ADDENDUM NUMBER		
ATTACHMENT NUMBER		
RECORD OF REVISIONS		
No.	DATE	DESCRIPTION
LAYOUT PLAN		
CHECKED BY: C. TRIPP		
DESIGNED BY: K. NOVIKOVA / T. FAGNANT		
DRAWN BY: K. NOVIKOVA / T. FAGNANT		
STATE OF ALASKA DEPARTMENT OF TRANSPORTATION & PUBLIC FACILITIES SOUTHEAST REGION		
SGY DYE A ROAD BRIDGE # 309 REPLACEMENT (TAYIA RIVER BRIDGE)		
LAYOUT PLAN		
PROJECT DESIGNATION NUMBER		
69275		
STATE	YEAR	
ALASKA	2011	
SHEET NUMBER	TOTAL SHEETS	
A2	13

TAIYA RIVER BRIDGE
 DYEA ROAD
 GENERAL LAYOUT

TAIYA RIVER BRIDGE
 DYEA ROAD
 LATERAL BRACING

PANEL A DETAILS

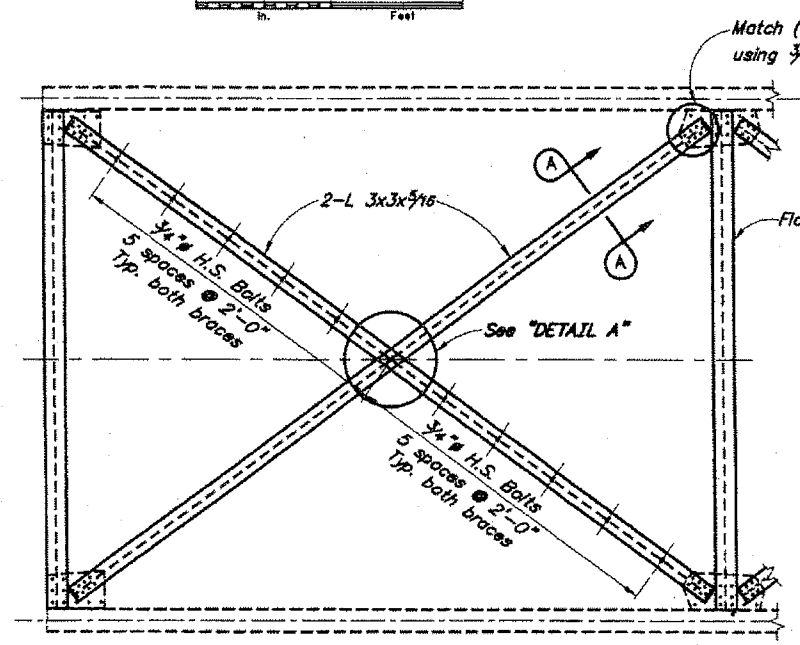
CHANGED HOLE LAYOUT TO FIT CONNECTION POINT. LAST 3 BAYS NORTH

DRILLED NEW HOLES CONNECTION POINT & CLIPS DID NOT ALIGN... LAST 2 BAY NORTH

TAIYA RIVER BRIDGE
DYEA ROAD
DECK

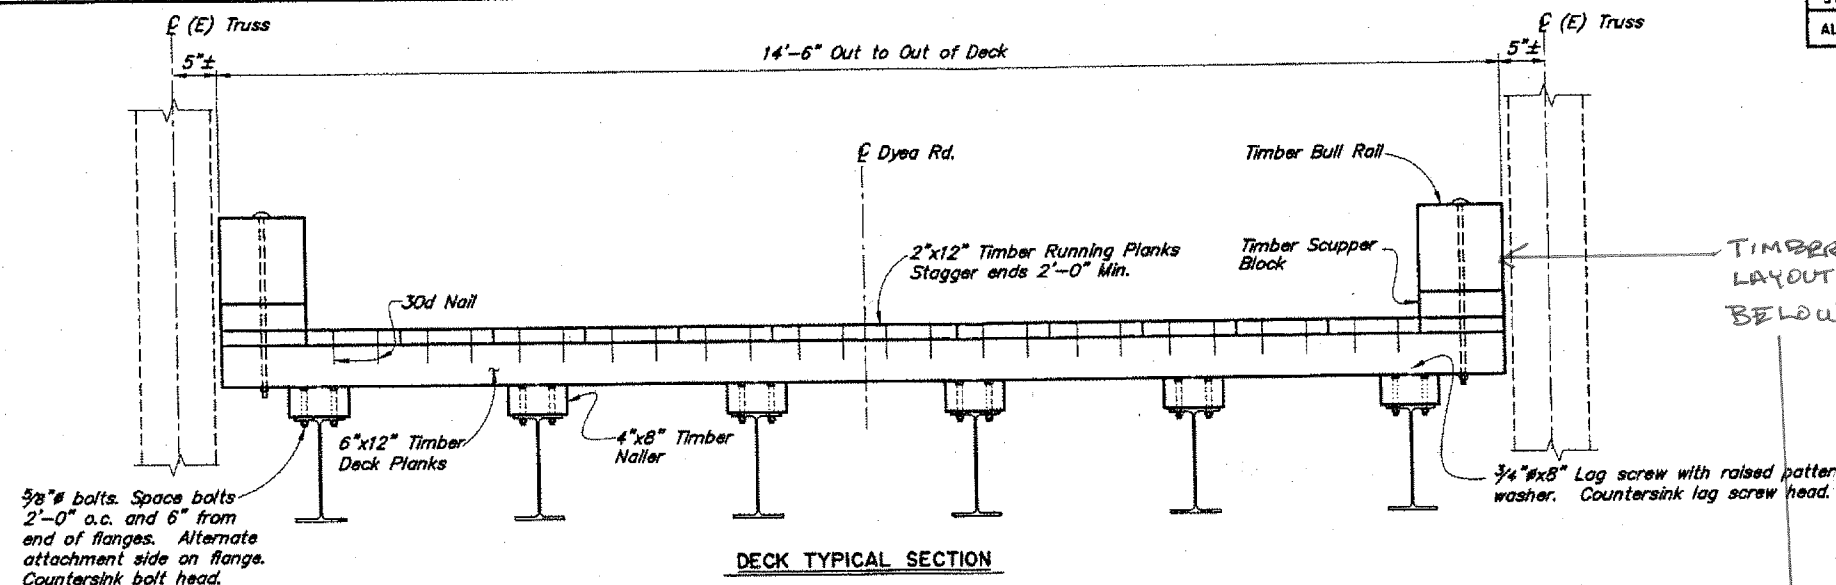
TIMBER BULL RAILS CHANGE TO 18' WITH CHANGED LAYOUT & TIMBER SCUPPER BLOCKS TO 4' SEE DETAIL BELOW

RUNNING PLANKS

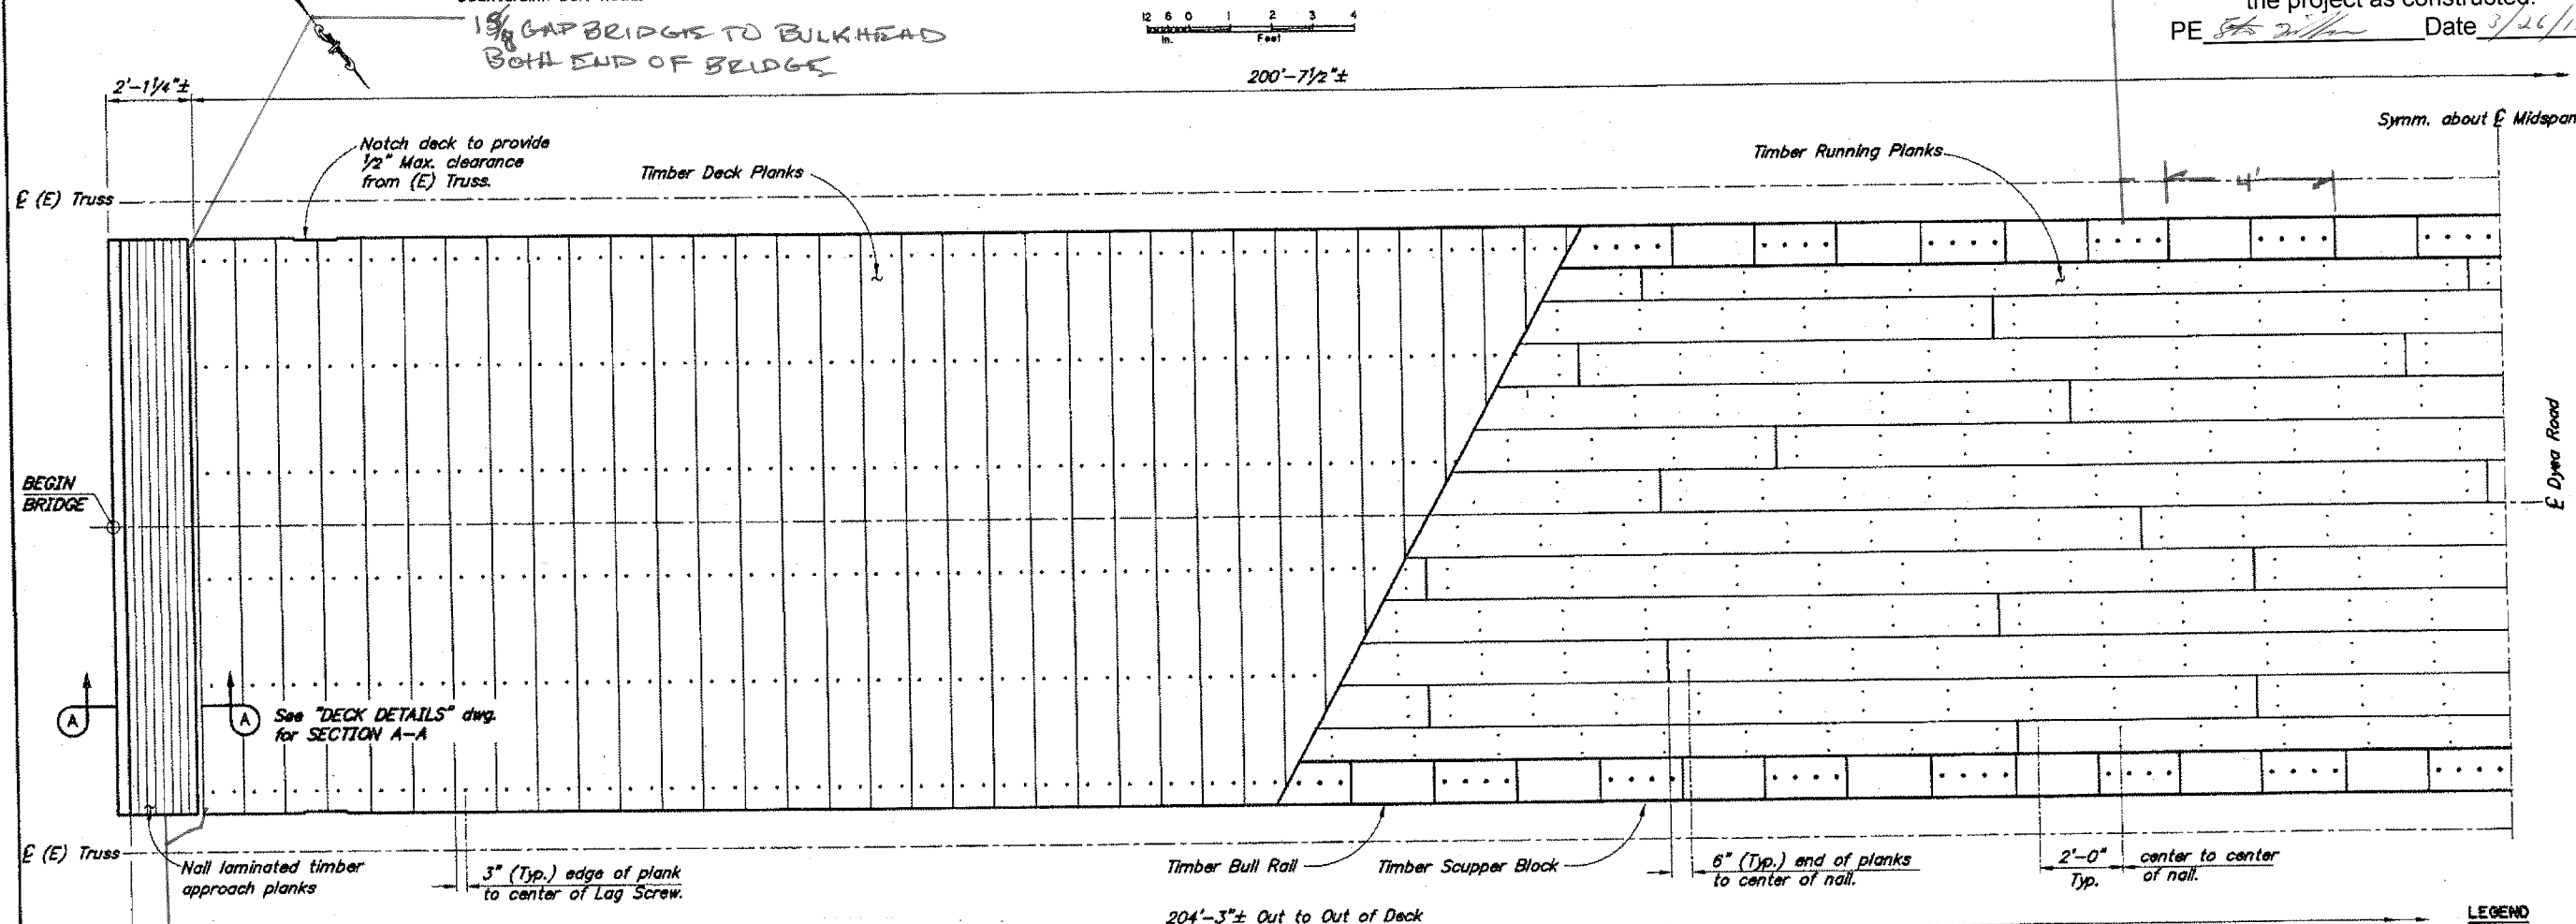
DECK PLANKS
NORTH END CHANGED TO 22"
ALSO ADDED BOARD TO BRIDGE SIDE TO FIX BROKEN ATTACHING
BOARDS RIP DOWN TO PORE CONCRETE.

BRIDGE RAIL - ELEVATION

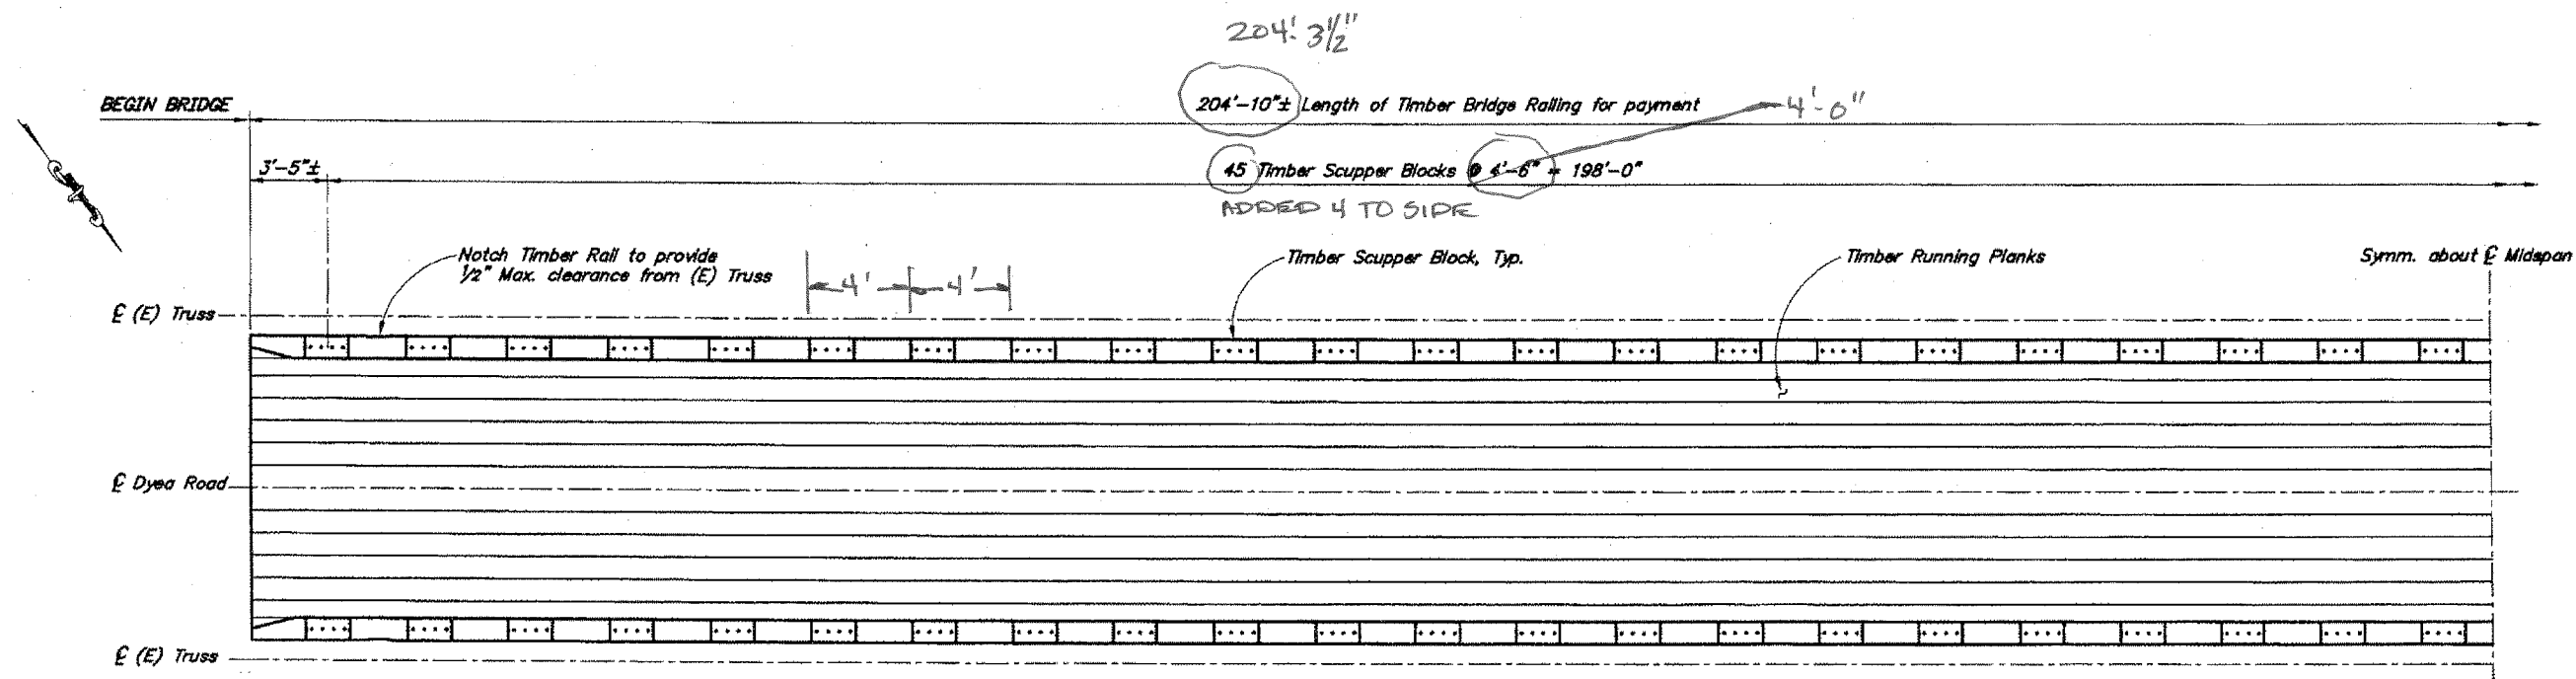
NOTE: LAST BULL RAIL CUT 11'-6" TO FINISH LAYOUT
 RATHER TO ARRIVE 12-27-11 TO FINISH 10 BOLTS 2 END RAILS 4 SCUPPER BLOCKS CLEAN UP.
